Toyota 86 / Subaru BRZ / Scion FR-S, Idler pulley alignment**SUMMARY:**

To prevent premature wearing of the supercharger drive belt, the idler pulley mount requires an additional bearing shim to be added to the idler pulley mount, prior to attaching the idler pulley to the idler pulley mount, to improve pulley alignment.

Step 2:

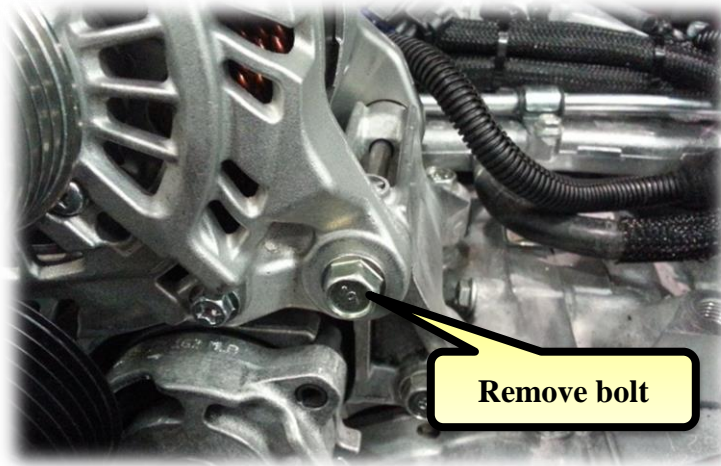
(Please note that the following steps replace step 26 of the installation manual 260_5D1000 Rev. 1.1)

- For new installations, remove the bolt from the alternator mount.

- Attach the bearing shim to the idler pulley mount.
- **NOTE:** Systems equipped with an Ø80mm or larger supercharger drive pulley requires the Ø60mm idler pulley to be fitted with a bearing shim. Systems equipped with an Ø75mm or smaller supercharger drive pulley, require the Ø70mm idler pulley to be fitted. If the Ø70mm idler pulley is to be fitted, it requires two bearing shims to be installed on the pulley mount behind the bearing.

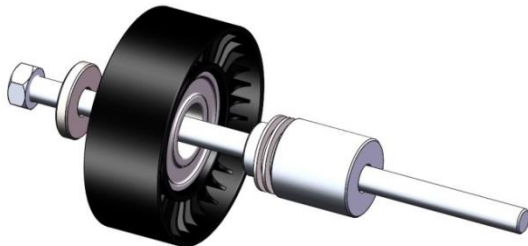
- Attach the supplied idler pulley mount, shim/s, idler pulley, M8 x 170 bolt and retaining washer to the alternator. Tighten to 23Nm.
